Waterbury Filing No. 1
Traffic Impact Analysis
SF237
(LSC #204222)
October 10, 2024

RE: Waterbury Filing No. 1
El Paso County, Colorado
Traffic Impact Analysis

Figure 12
2045 Total Traffic,
Lane Geometry and Traffic Control

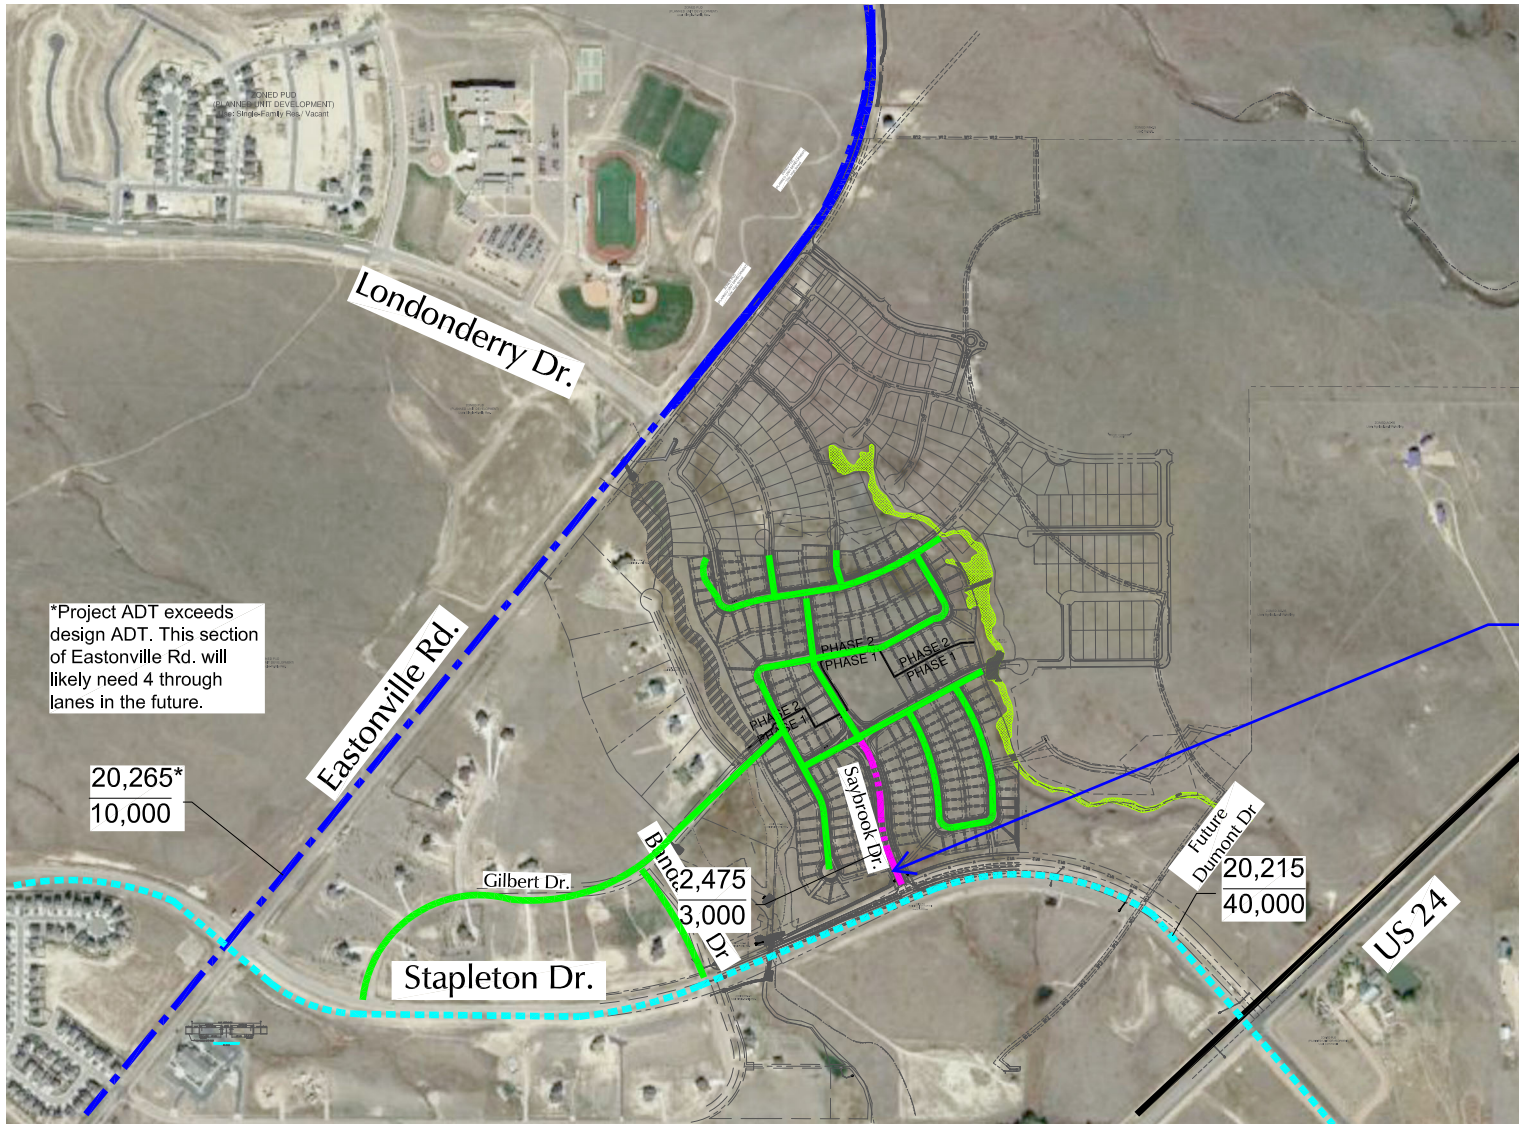
add ADT on Saybrook

Map 15 Bicycle and Pedestrian Network Improvements

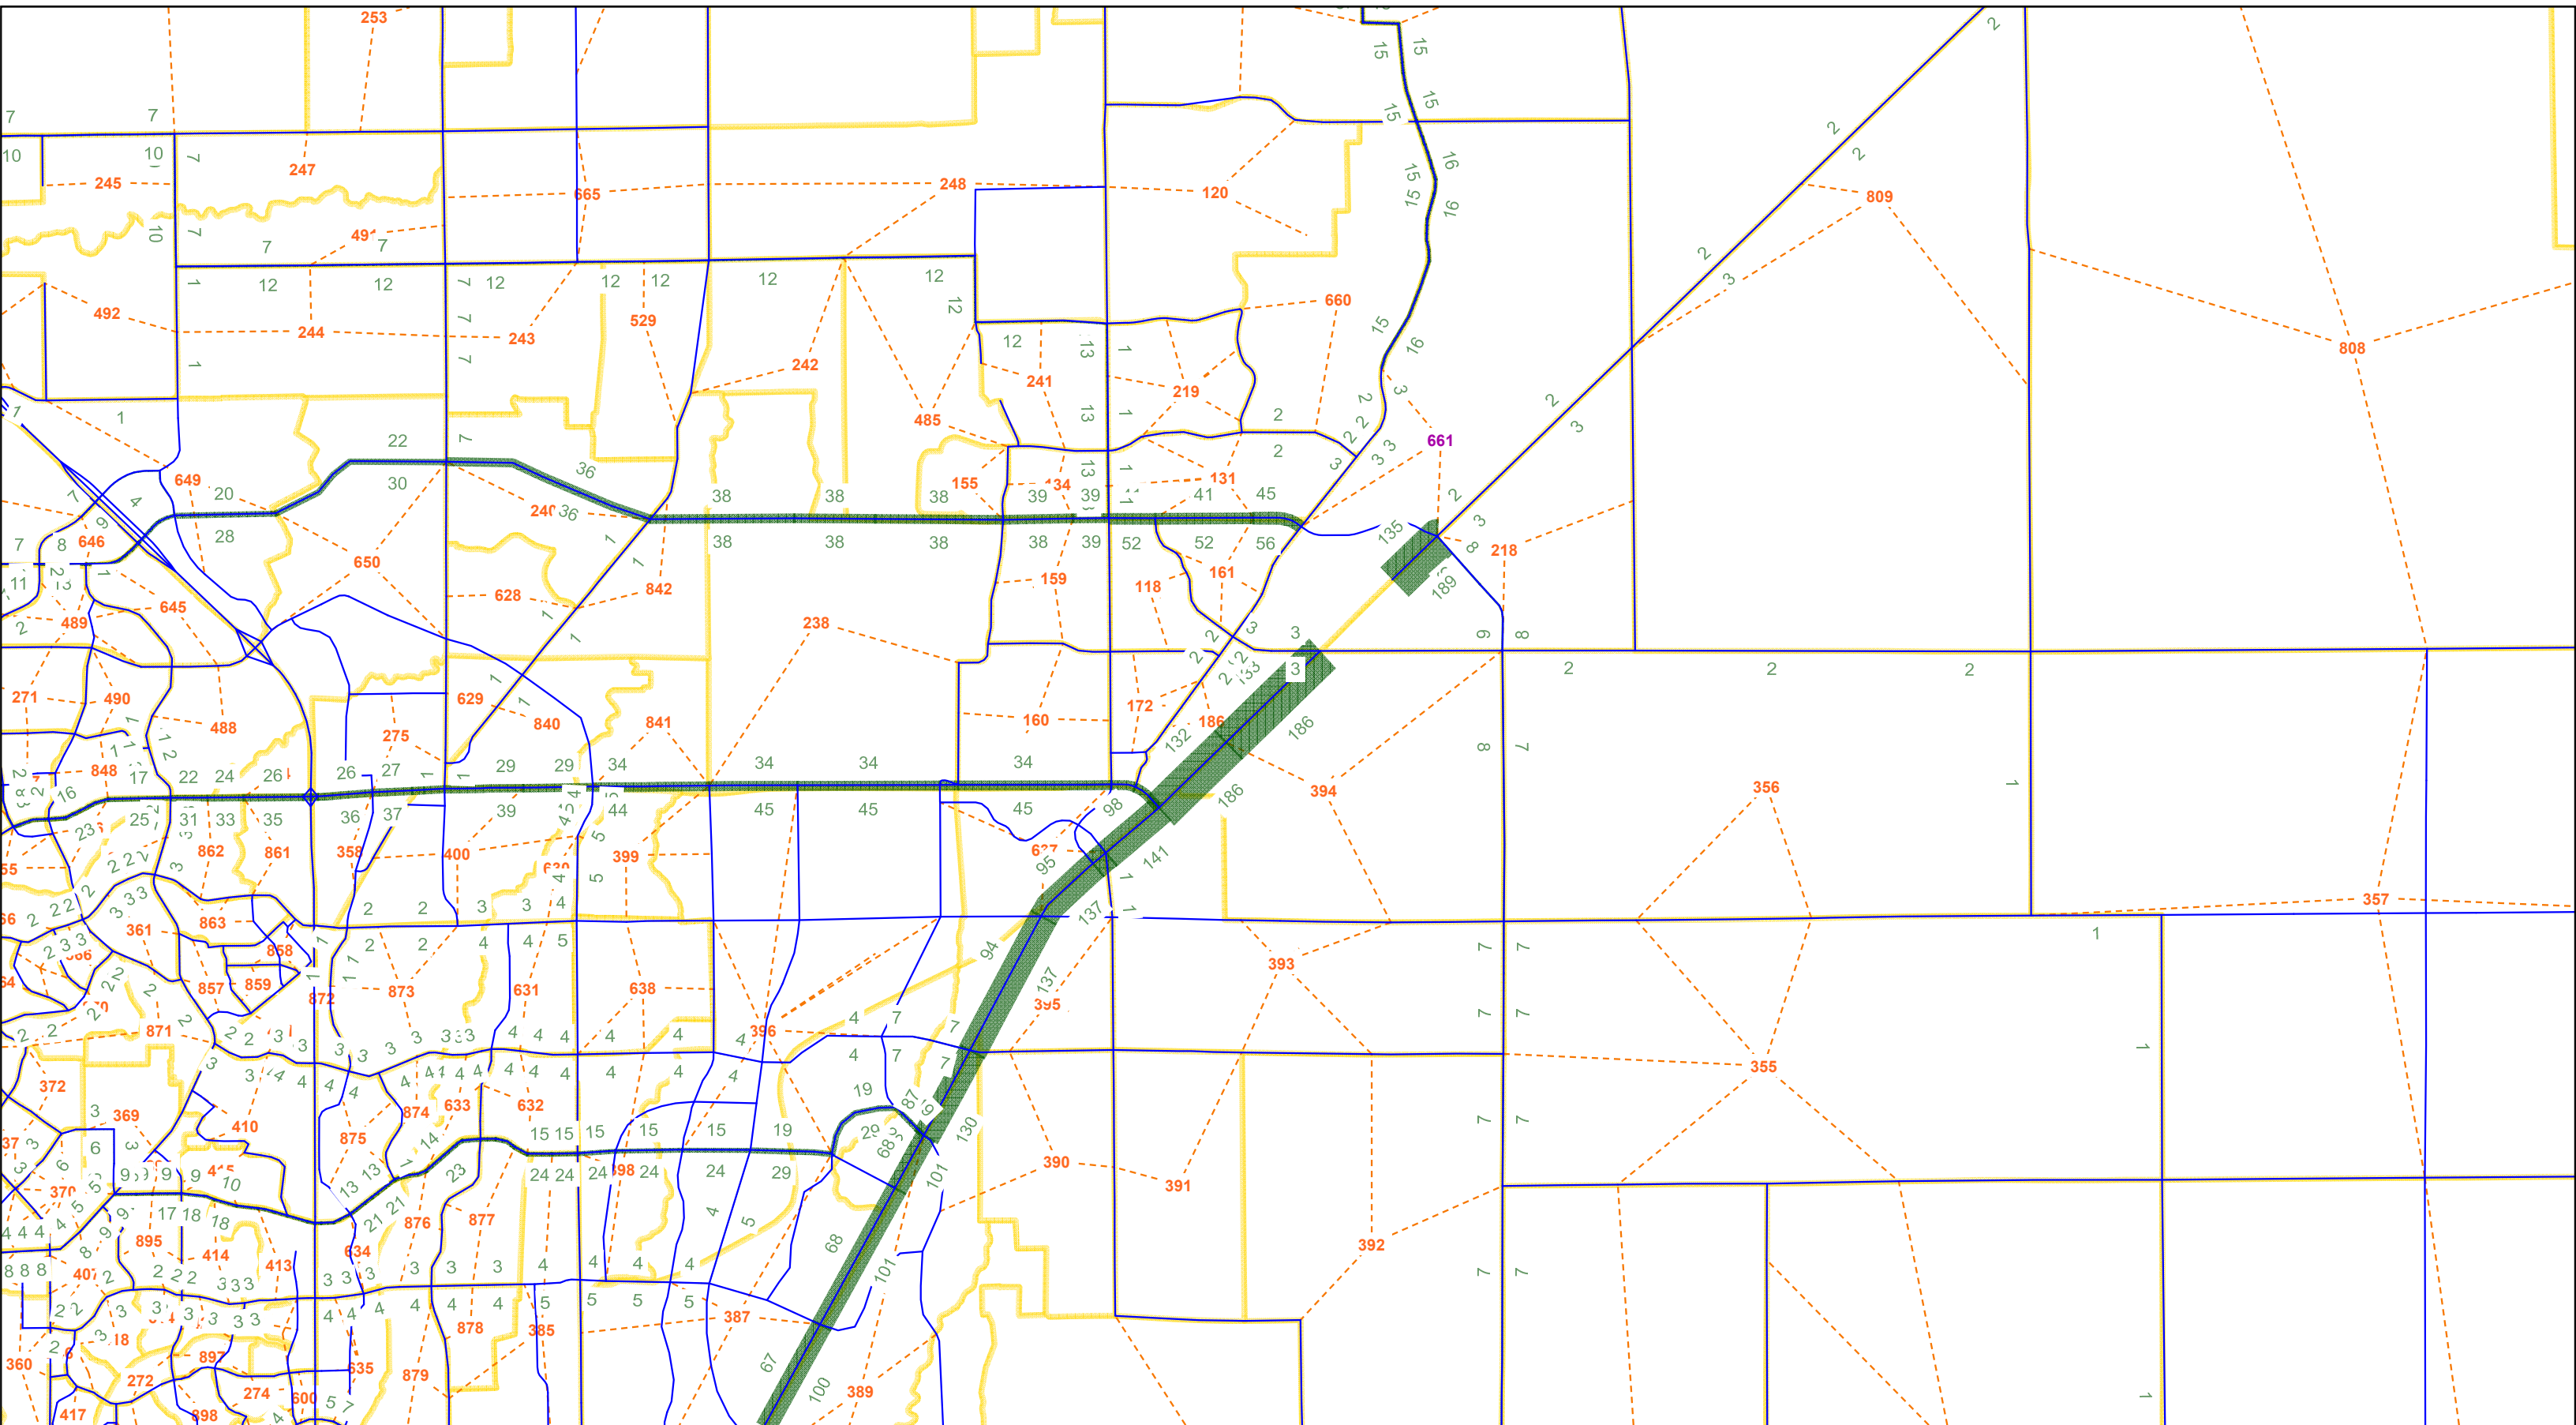
This is not Map 15; Update per new MTCP?
